Atherton Hospital Redevelopment

MAIL TYPE	MAIL NUMBER	REFERENCE NUMBER
General Correspondence	FKG-GCOR-008263	FKG-RFI-001227

Re: URGENT - Level 1 Rectification Alternative

Subject: URGENT - Level 1 Rectification Alternative

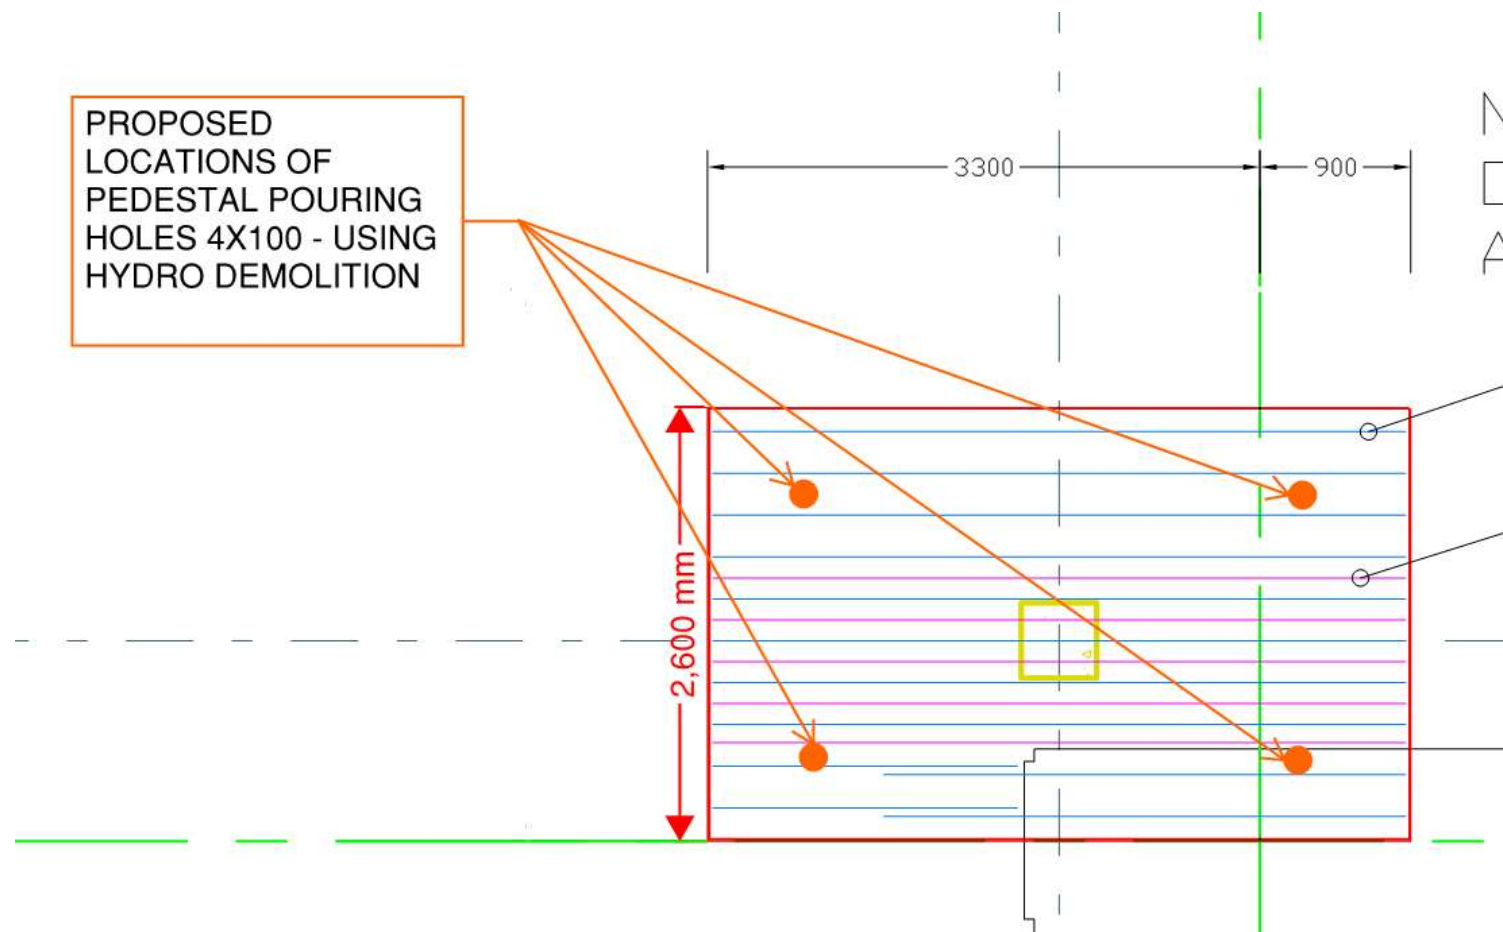
Hi Brendan,
please find attached for construction rectification detail.
With regards to the information provided by FKG:
1. number of holes required is 12 and not 4 as noted below by FKG. We have attached a sketch showing indicatively the location of these holes.
2. Can FKG please confirm shrinkage parameters of the proposed concrete mix (we have not been able to find this information in the document provided).
Regards

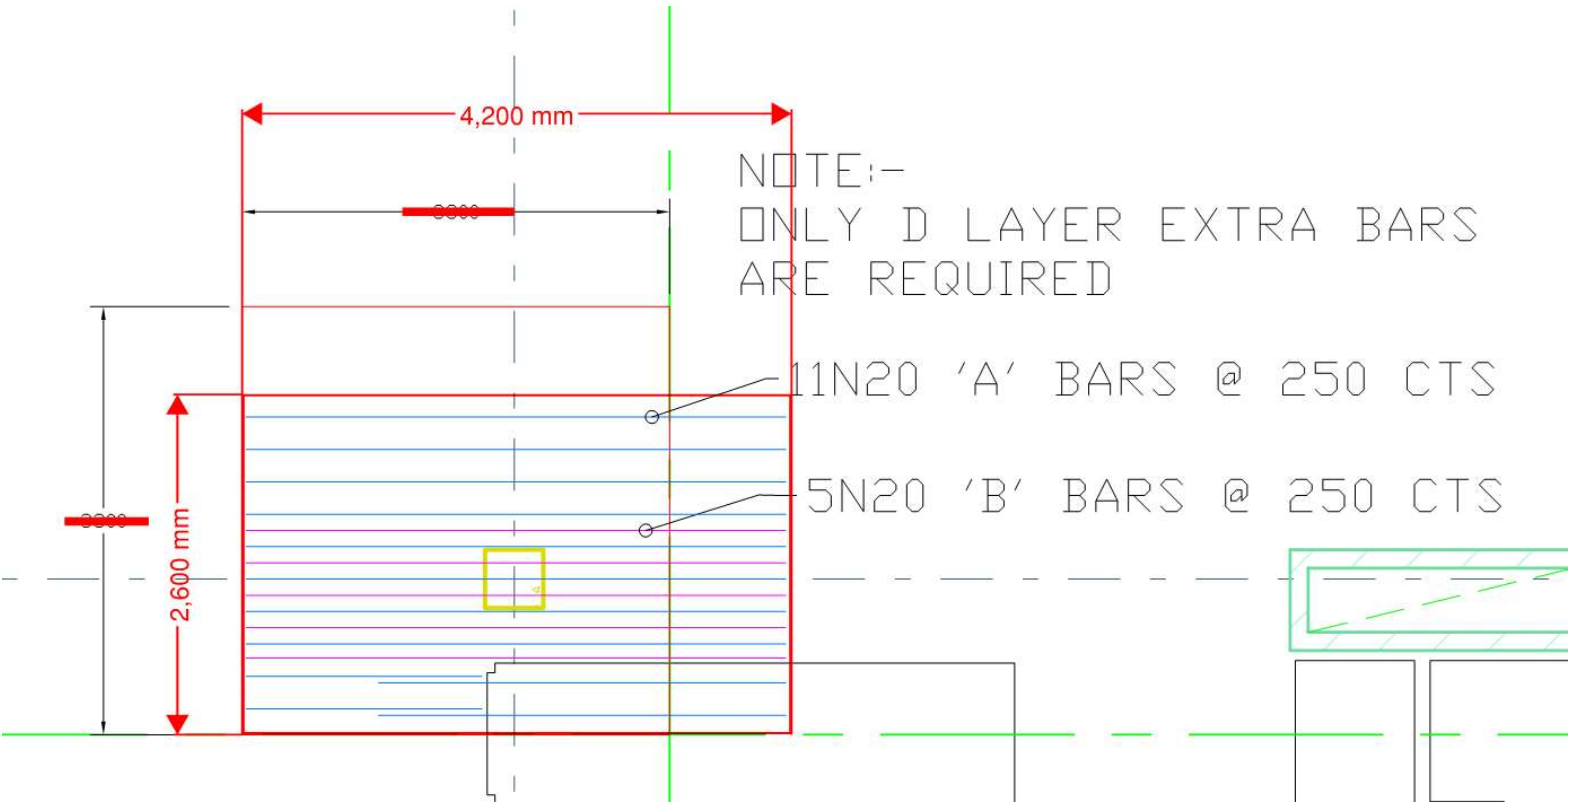
Please be aware that FKG are preparing to using hydro-demolition for the demolition component of this rectification. FKG are using this method to ensure the integrity for the reinforcement through the existing slab is maintained. FKG will undertake these critical works demolition on Wednesday this week (29/09/2021). This timing is critical to FKG to ensure that the hydro-demolition can be undertaken in the most practical time frame for on-site works to continue.

As per your note on the drawings FKG will be supplying the backpropping design, documentation and certification, with slab back propping being undertaken tomorrow (28/09/2021) so further rectification works can continue.

As discussed on the phone with Daniele this afternoon, please confirm if the below area of proposed demolition (4.2m x 2.6m) and potentially pedestal could be adopted during these rectification works.

The proposed demolition extent is acceptable. It is understood that on the southern side of grid 3 the demolition will extend up to the construction joint.

We will be able to confirm extent of drop panel, confirm acceptance of proposed concrete mix and issue the for construction drawing by the end of the week.

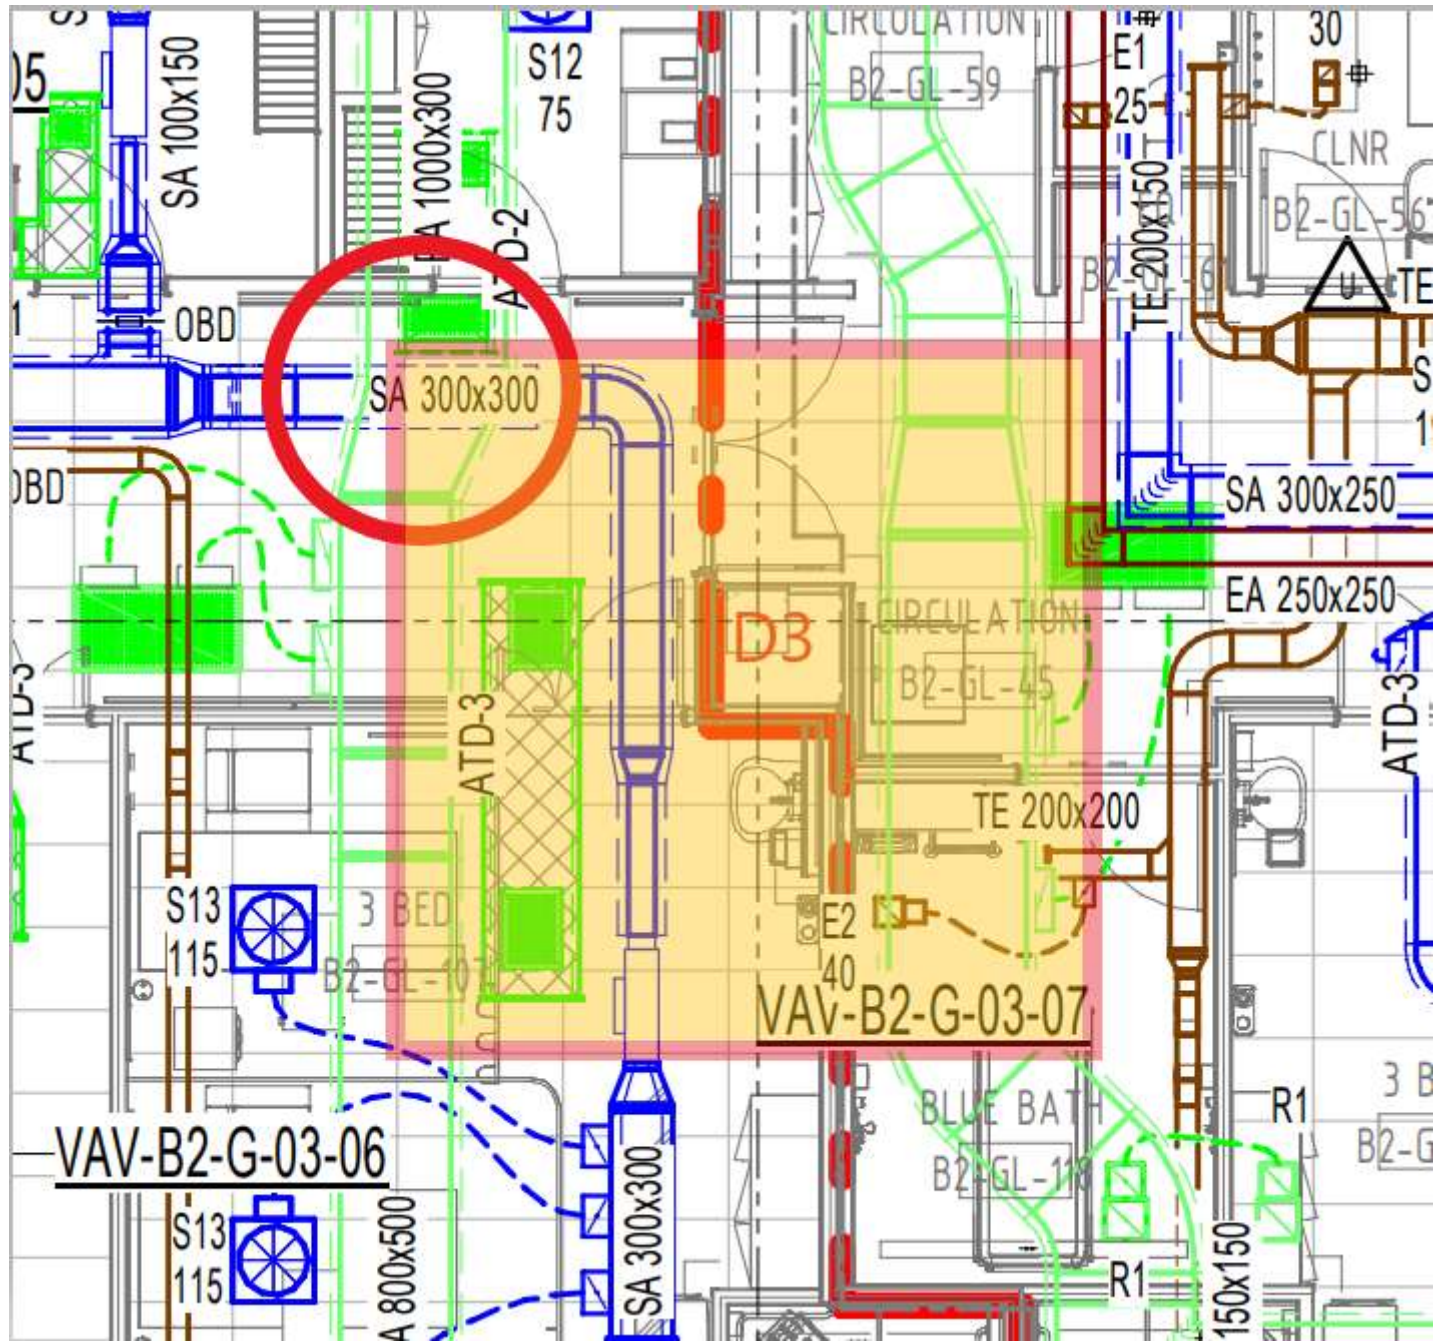
We note that it will have a minor clash with some of the mechanical ductwork shown circled below.

However we anticipate that this will be coordinated between yourselves and VAE?

VAE and FKG are currently working together to co-ordinate the services to ensure minimum interruptions to the services trades.
